RFB-2025-28
SCHENECTADY COUNTY DMV PARKING LOT IMPROVEMENTS

ADDENDUM #2

Date: 03/06/2025

C-111

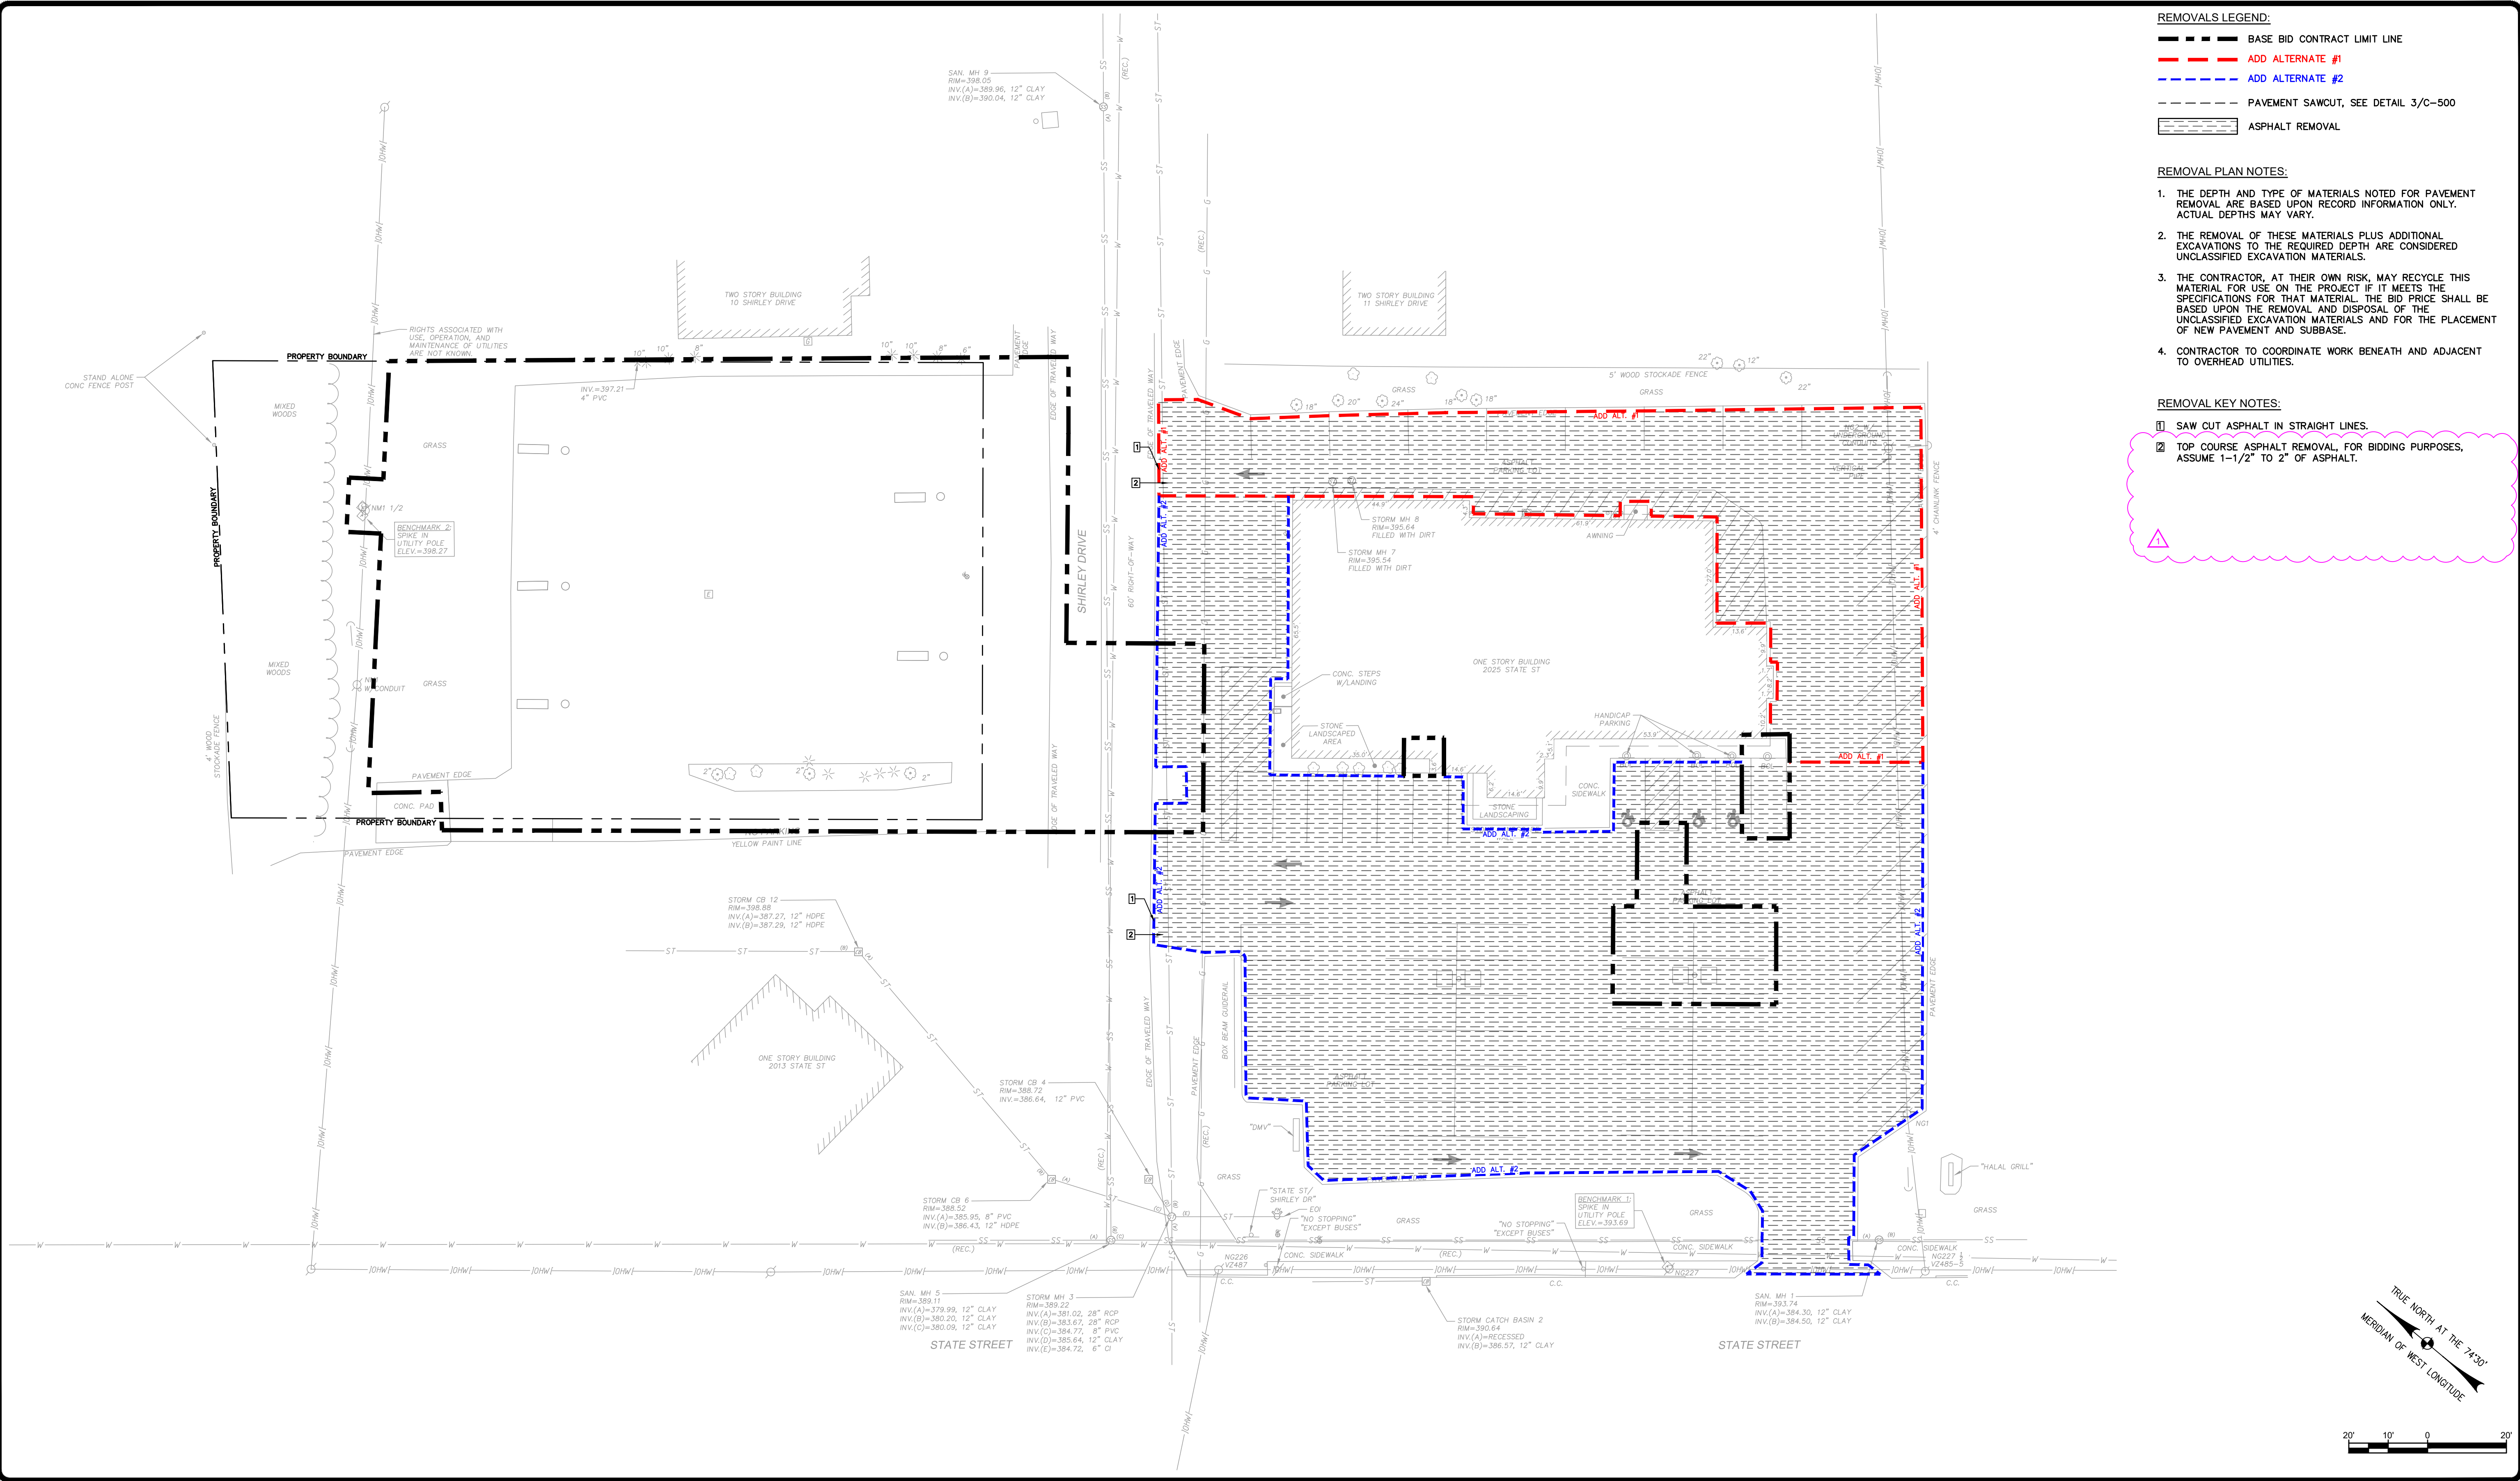
1. It is called out on several pages to mill and fill the parking lots (base bid and alternates), and it is assumed for bidding purposes to mill 4", however, all the callouts for the proposed asphalt section refer to the Asphalt Paving detail 1/C-500 which is a full depth replacement detail. What is the proposed asphalt section in the mill and fill limits?

- REMOVAL KEY NOTES:**
- ① SAW CUT ASPHALT IN STRAIGHT LINES.
 - ② TOP COURSE ASPHALT REMOVAL, FOR BIDDING PURPOSES, ASSUME 1-1/2" TO 2" OF ASPHALT.

For the Base Bid area (Shirley Drive Lot), asphalt is to be fully removed (approx. 4") to the subbase course. Additional Type 2 subbase will be required in some areas to bring the parking lot up to proposed grade. Detail 1/C-500 represents the

minimum subbase required, so subbase depths can exceed 12” at the Base Bid lot (Shirley Drive Lot).

For the Add Alternate areas #1 and #2, milling should only remove the top course. The top course may be between 1-1/2” and 2”. The contractor shall refer to C-121 (RFI#1 / Addendum #2), Detail 1/C-500, and specification section 321216 for replacing the asphalt top course. The new top course may be 1-1/2” and 2” depending on how much asphalt is removed. The contractor is responsible for matching all finished grades.

C-121

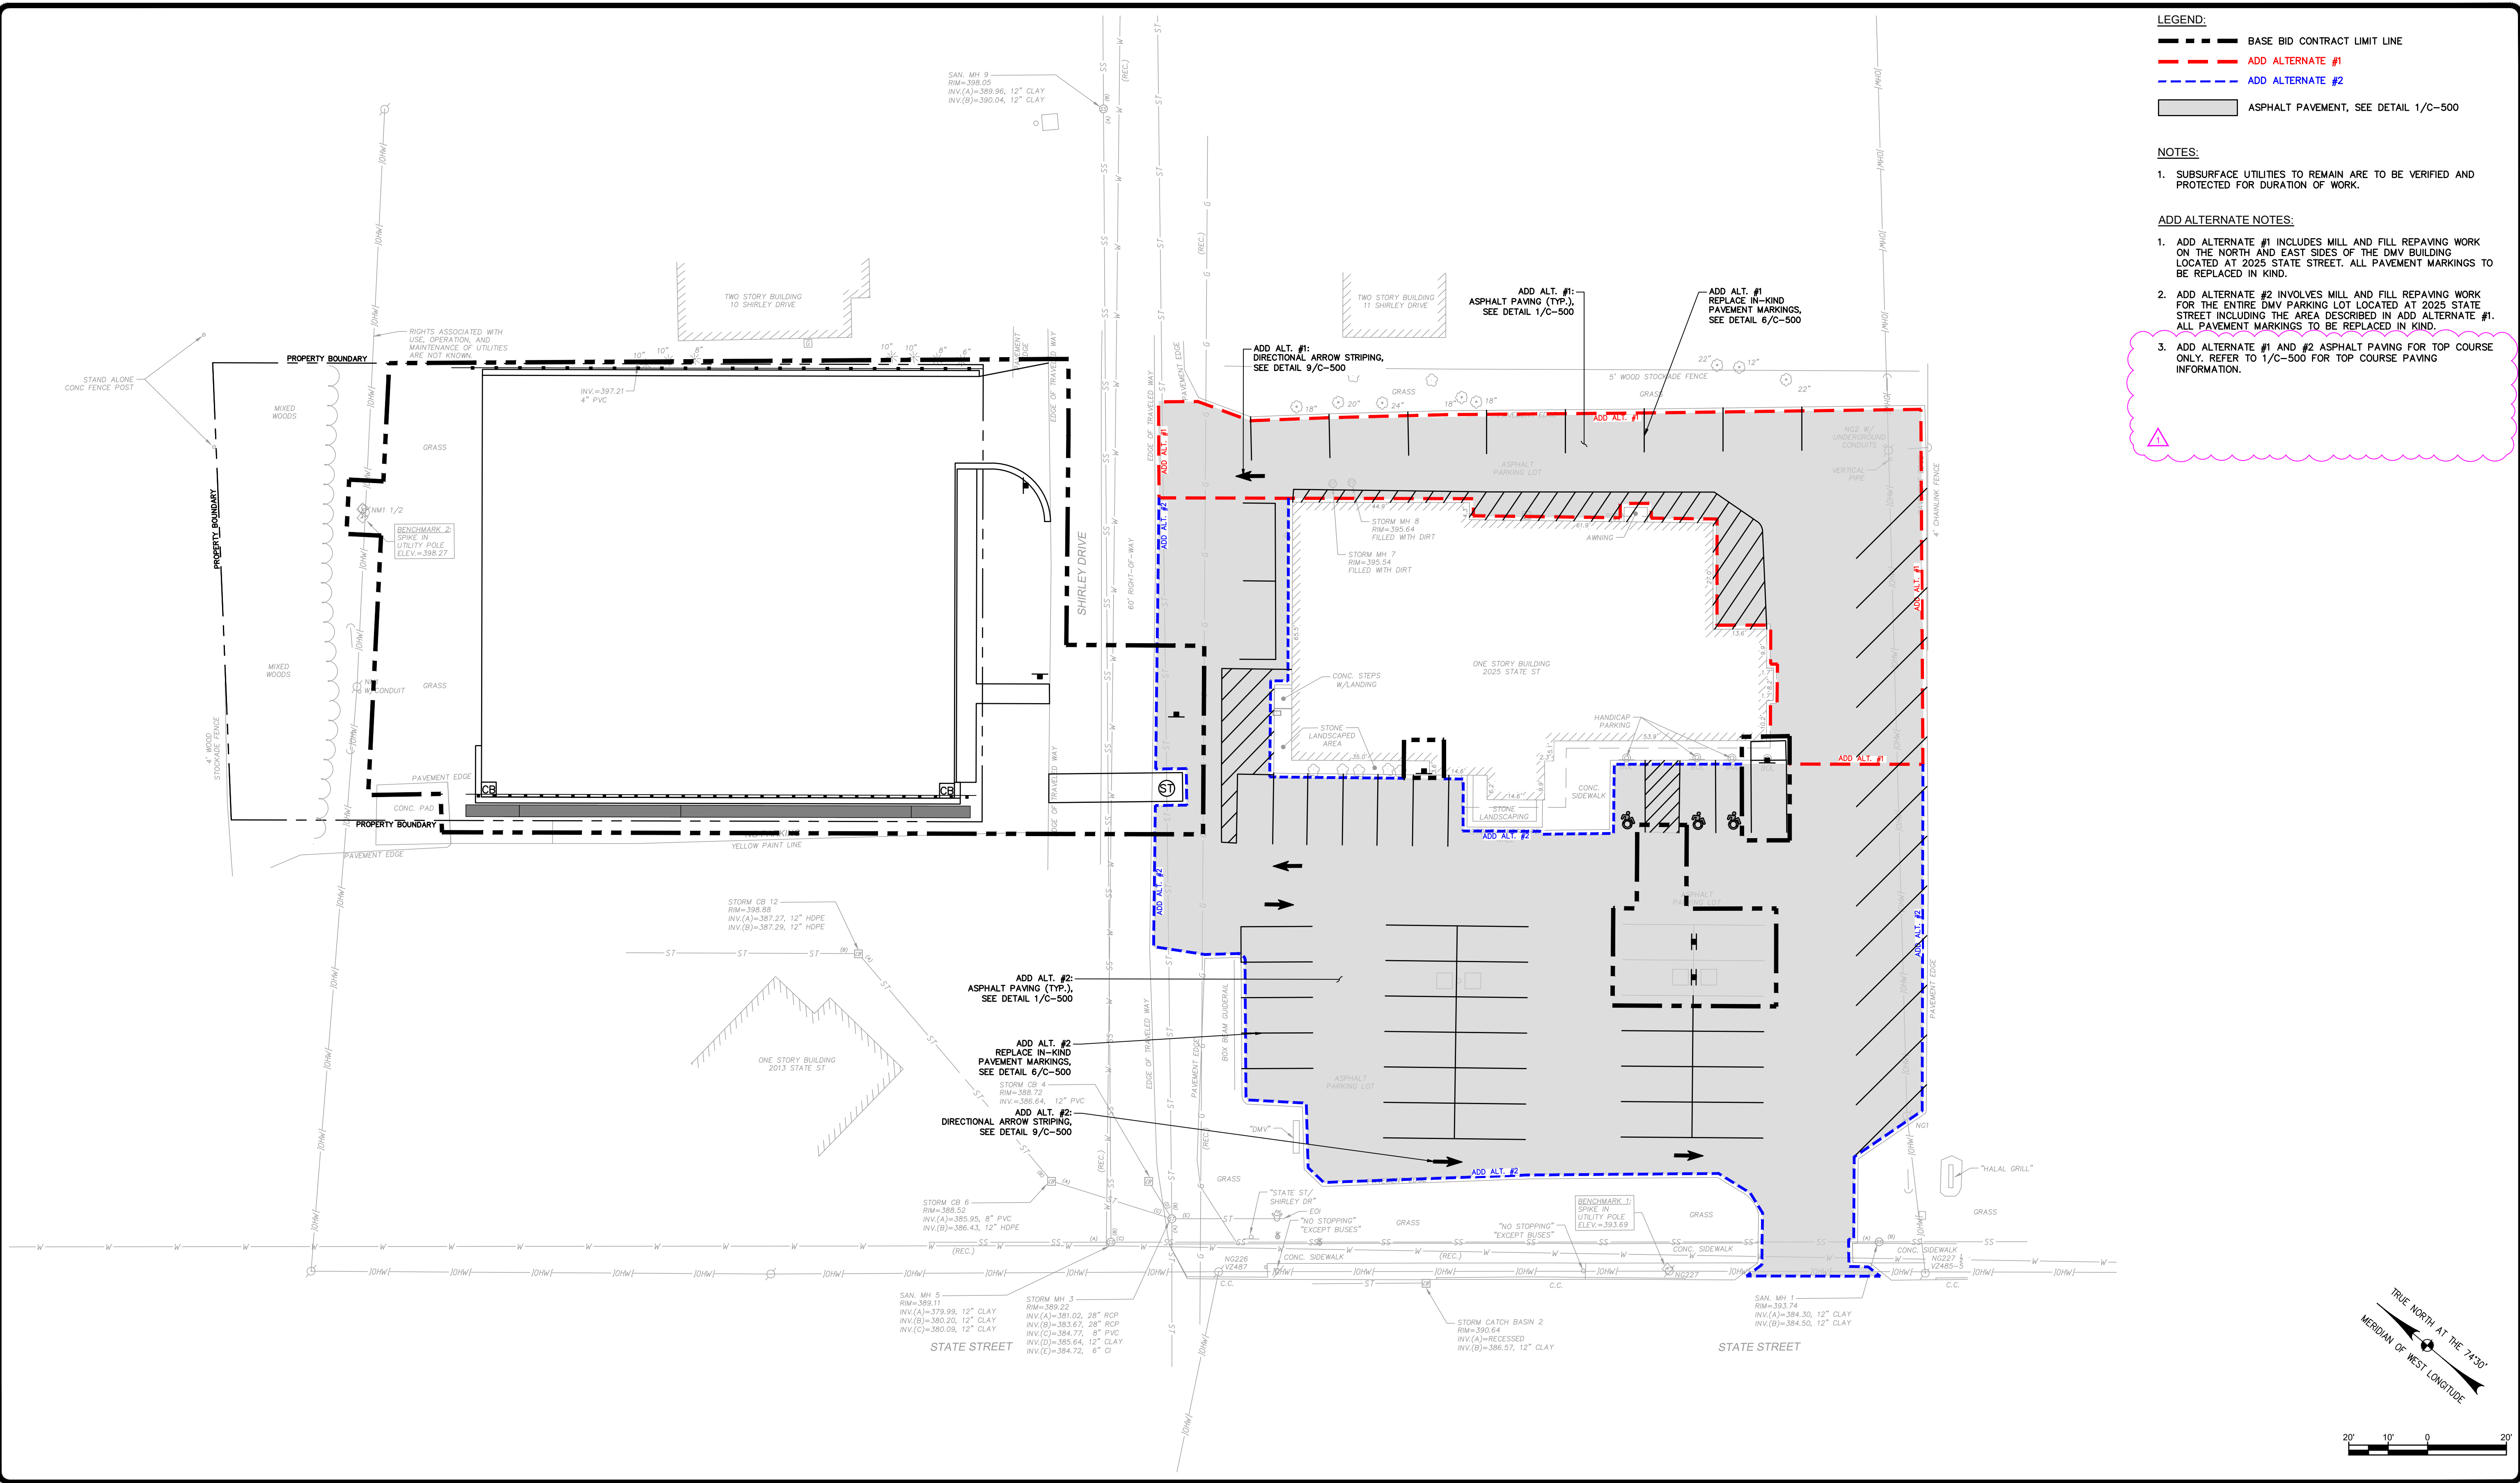
- LEGEND:**
- BASE BID CONTRACT LIMIT LINE
 - - - - - ADD ALTERNATE #1
 - - - - - ADD ALTERNATE #2
 - ASHPALT PAVEMENT, SEE DETAIL 1/C-500
- NOTES:**
- SUBSURFACE UTILITIES TO REMAIN ARE TO BE VERIFIED AND PROTECTED FOR DURATION OF WORK.
- ADD ALTERNATE NOTES:**
- ADD ALTERNATE #1 INCLUDES MILL AND FILL REPAVING WORK ON THE NORTH AND EAST SIDES OF THE DMV BUILDING LOCATED AT 2025 STATE STREET. ALL PAVEMENT MARKINGS TO BE REPLACED IN KIND.
 - ADD ALTERNATE #2 INVOLVES MILL AND FILL REPAVING WORK FOR THE ENTIRE DMV PARKING LOT LOCATED AT 2025 STATE STREET INCLUDING THE AREA DESCRIBED IN ADD ALTERNATE #1. ALL PAVEMENT MARKINGS TO BE REPLACED IN KIND.
 - ADD ALTERNATE #1 AND #2 ASPHALT PAVING FOR TOP COURSE ONLY. REFER TO 1/C-500 FOR TOP COURSE PAVING INFORMATION.
